CITY OF KELOWNA

MEMORANDUM

File No.: Z24-0029

Subject: 1256, 1260, and 1270 Glenmore Dr RU1 to MF3

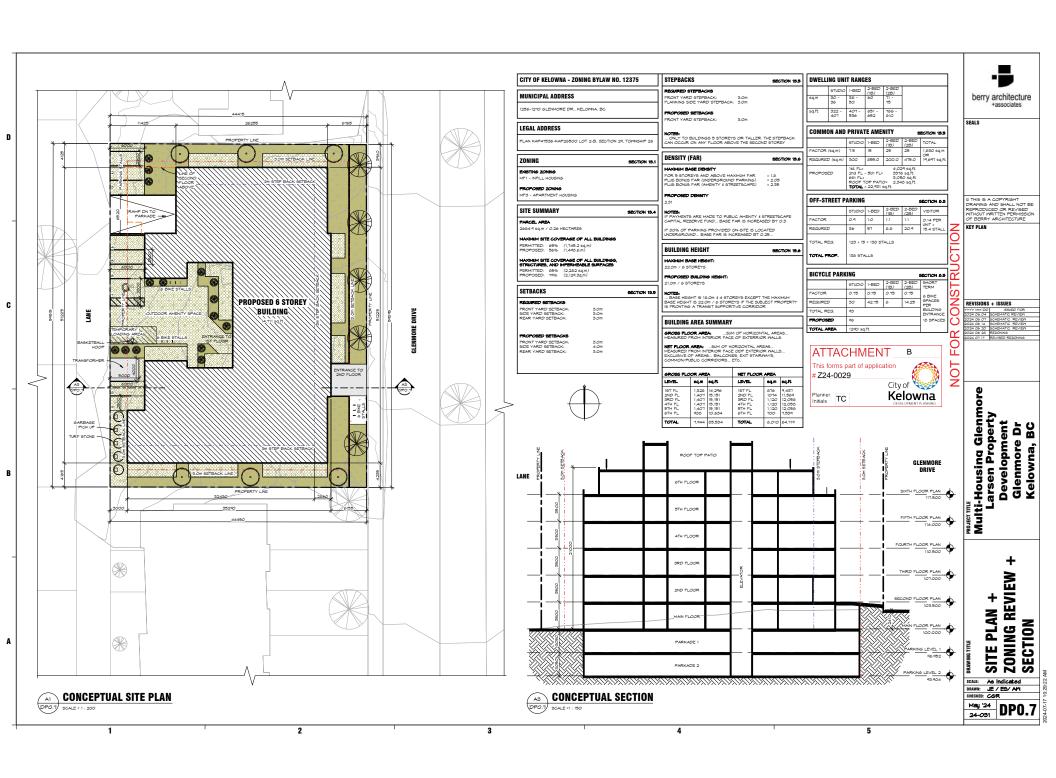
- a. Approximately 0.35 m road dedication along the entire frontage of Glenmore Dr is required to achieve a ROW width of 31.5 m to match the adjacent property to the north.
- b. The applicant is advised that no municipal storm drainage system services or fronts the subject properties. If the underlying soils are not suitable for infiltration, the applicant may be required to extend the municipal storm sewer to their property.
